Clause 173 was added to IEEE Std 802.3-2022 by IEEE Std 802.3df-2024:

173. Physical Medium Attachment (PMA) sublayer, type 800GBASE-R

Figure 173–4—8:32 PMA functional block diagram

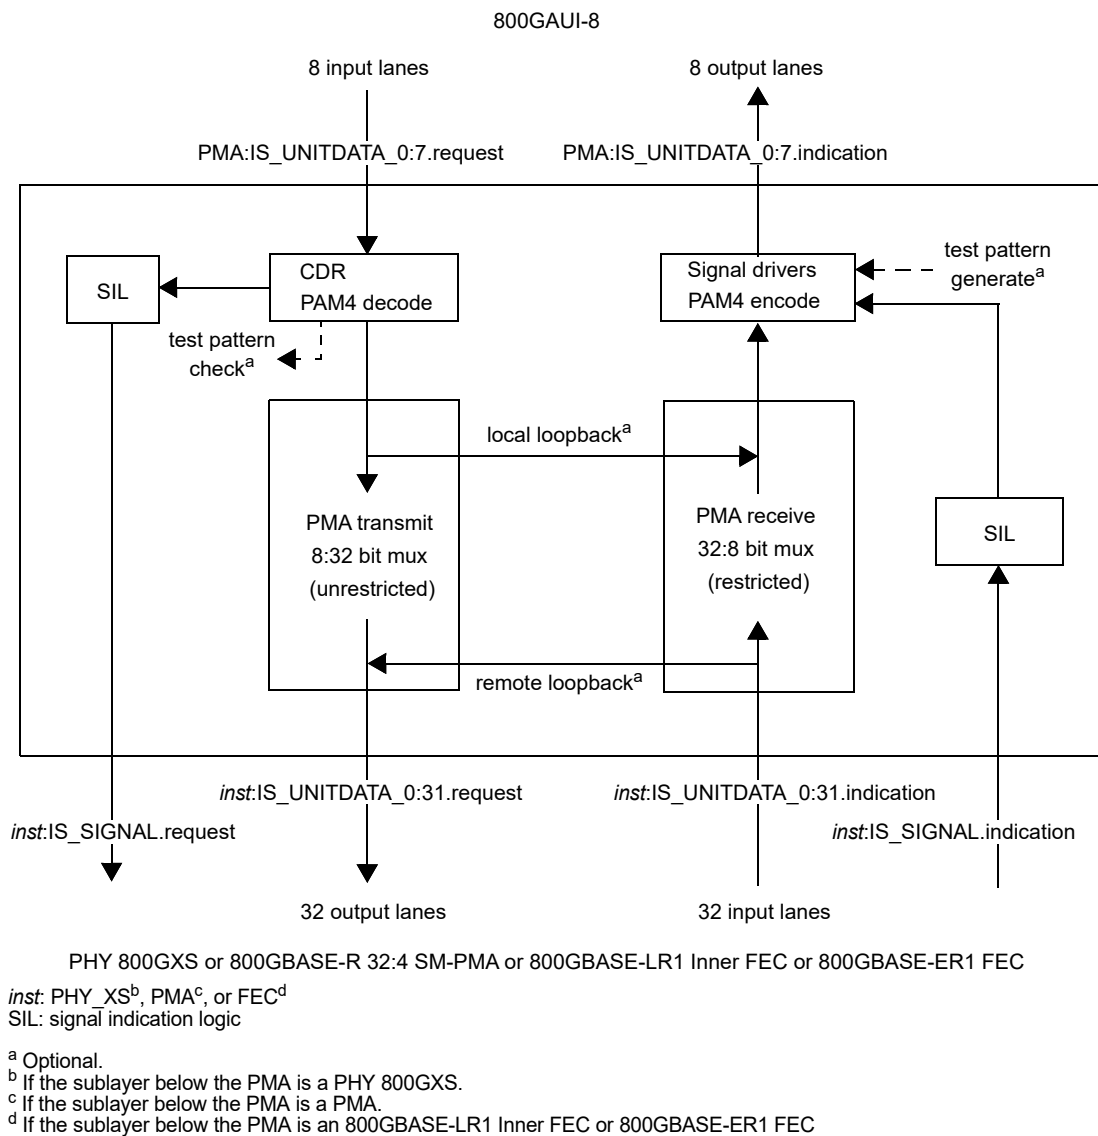
Replace Figure 173–4 with the following:
